Duke Energy Corporation

McGuire Nuclear Station
12700 Hagers Ferry Road
Huntersville, NC 28078-9340
(704) 875-4800 OFFICE
(704) 875-4809 FAX

Subject: McGuire Nuclear Station, Units 1 and 2
Docket Nos. 50-369 and 50-370
Proposed Revision to Technical Specifications (TS)
TS 3.3.2 - Engineered Safety Feature Actuation System
(ESFAS) Instrumentation
TS 3.4.3 - Reactor Coolant System Pressure and
Temperature Limits
TS 3.4.12 - Low Temperature Overpressure Protection
System

Figure 3.4.3-2 RCS Cooldown Limitations
(UNIT 2 ONLY)

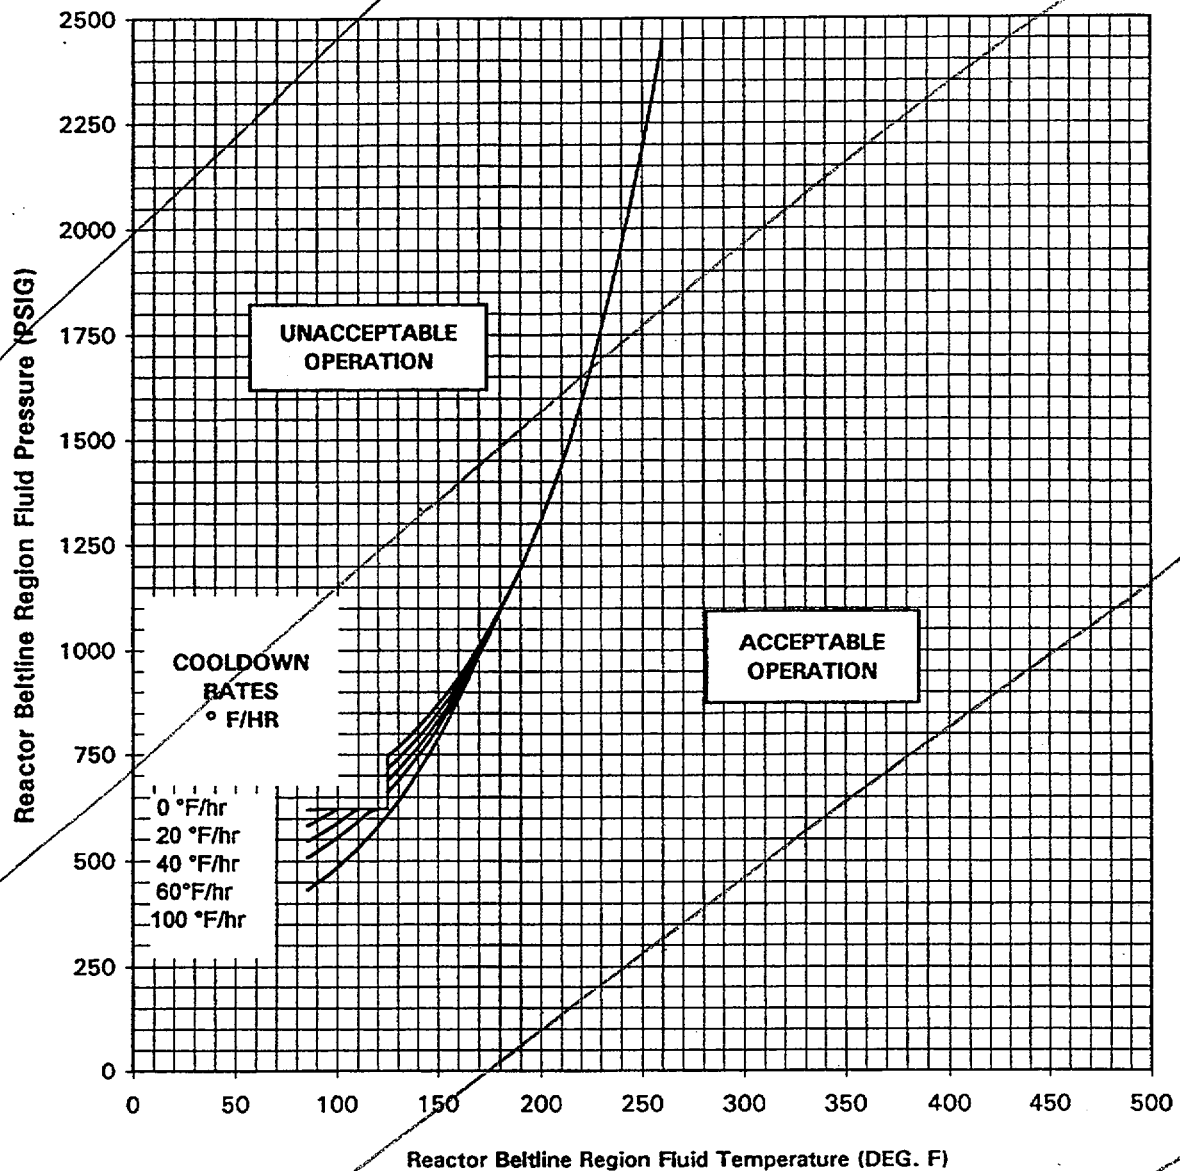
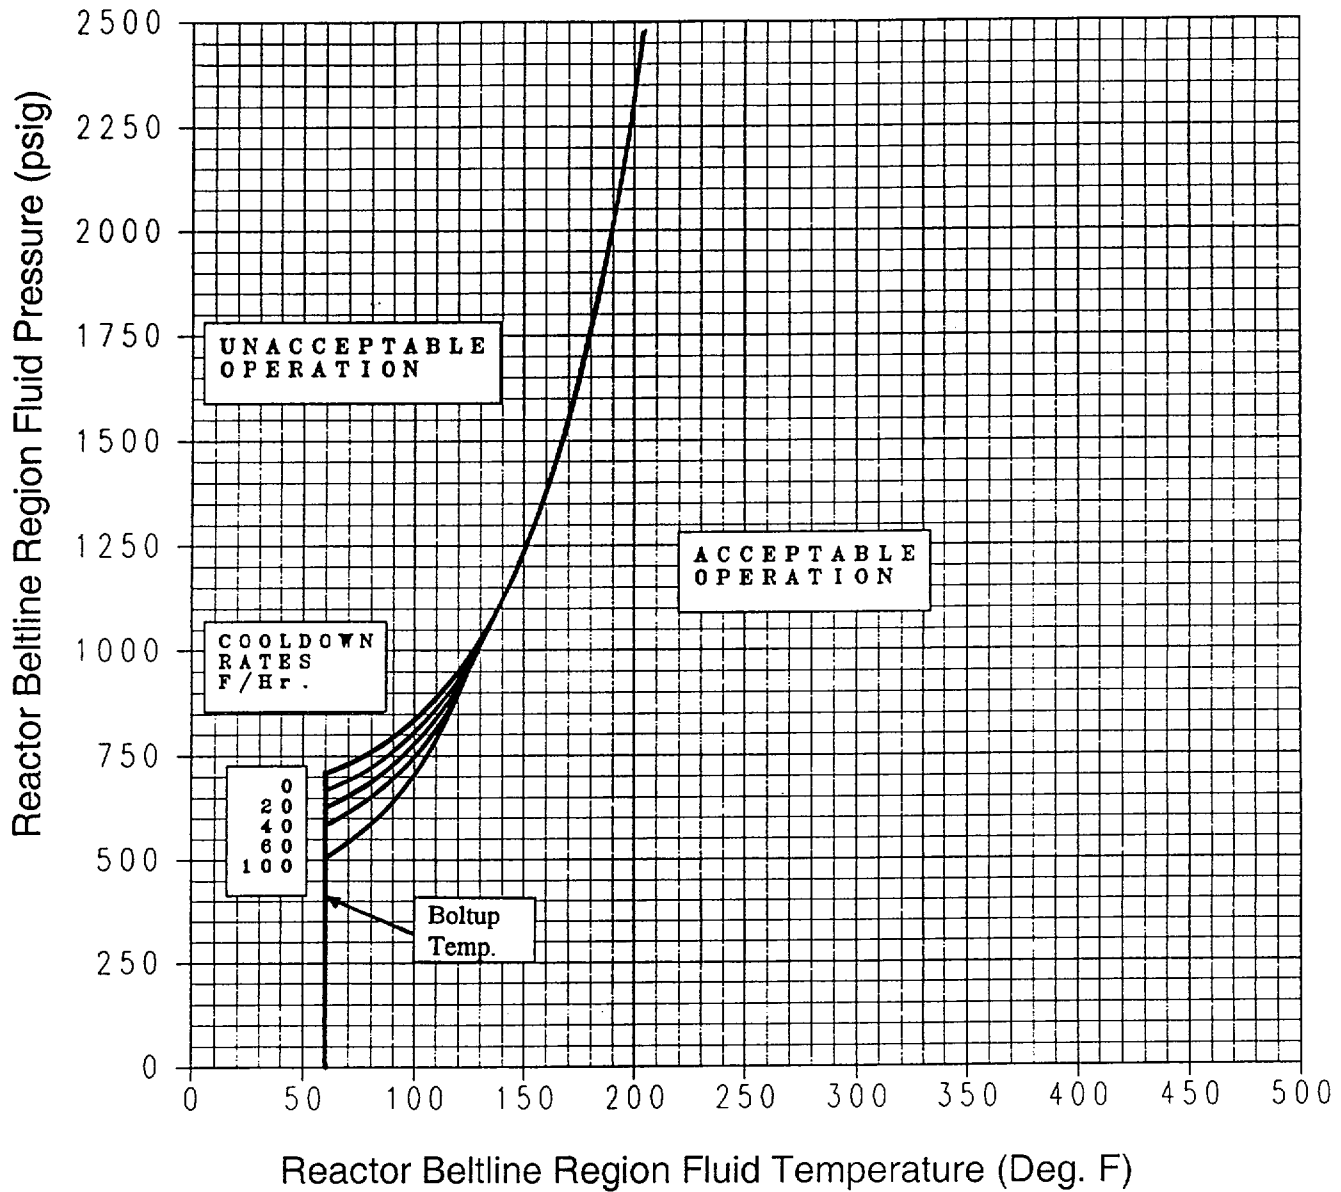
(Replaced by next figure)

TS 3.4.3 is revised to reflect the new P/T limits which are effective to a maximum of 34 EFPY for Units 1 and 2. Figure 3.4.3-1 currently has two heatup figures, one for each unit. Figure 3.4.3-2 currently has two cooldown figures, one for each unit. Figure 3.4.3-1 will be replaced with four heatup figures (Figures 3.4.3-1 through 3.4.3-4), two for each unit. Figure 3.4.3-2 will be replaced with two cooldown figures (Figures 3.4.3-5 and 3.4.3-6), one for each unit. Limiting condition for operation (LCO) 3.4.3 is revised to refer to these new figures. The technical justification for this change is included in Section 3.2.

McGuire Unit 2 Reactor Coolant System Cooldown Limitations (Cooldown Rates of 0, 20, 40, 60 and 100° F/hr) Applicable to 34 EFPY (Without Margins for Instrumentation Errors)

Figure 1
(Unit 1)

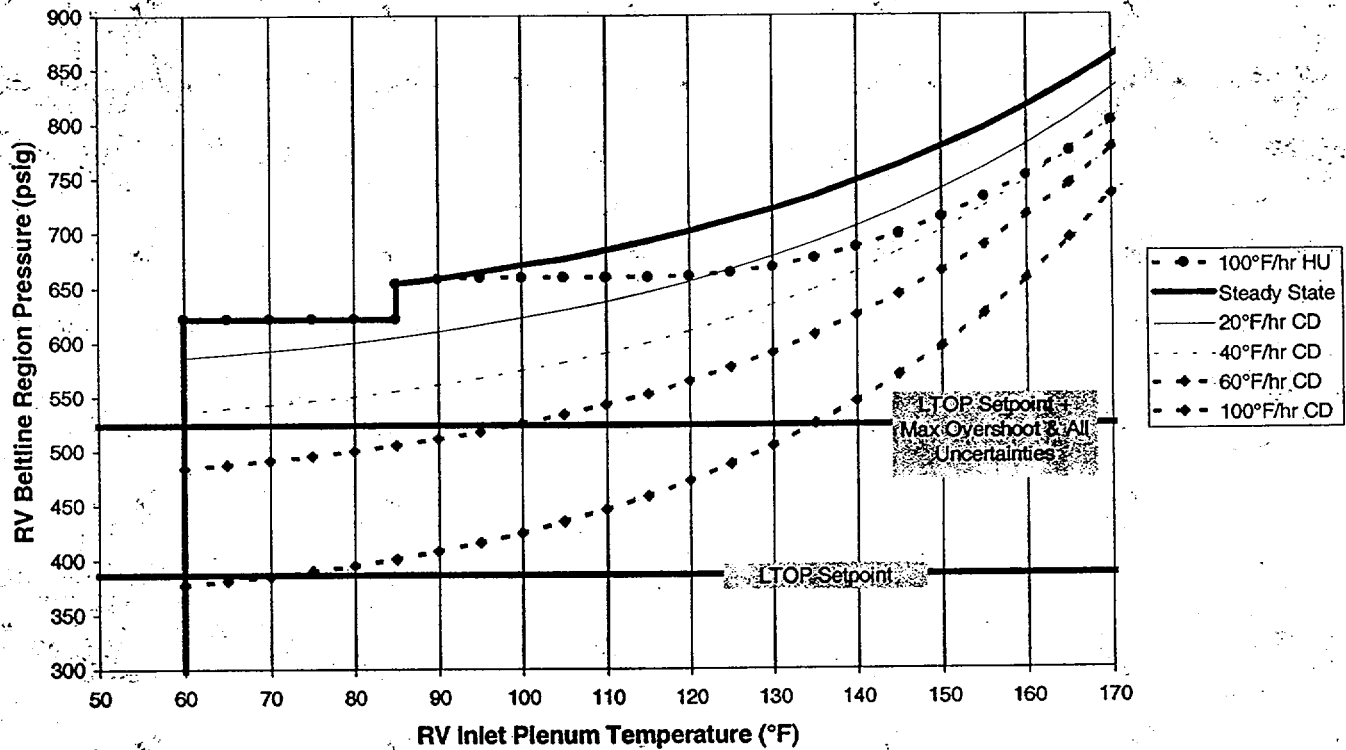
Figure 1 illustrates the Appendix G limits for heatup and cooldown rates along with the LTOP setpoint and highest peak pressure indicated in Table 3. From this figure, it can be seen that a cooldown rate of 100 °F/hr with beltline fluid temperature below 135 °F is insufficient to preserve Appendix G margins to brittle failure. Similar limitations exist for a cooldown rate
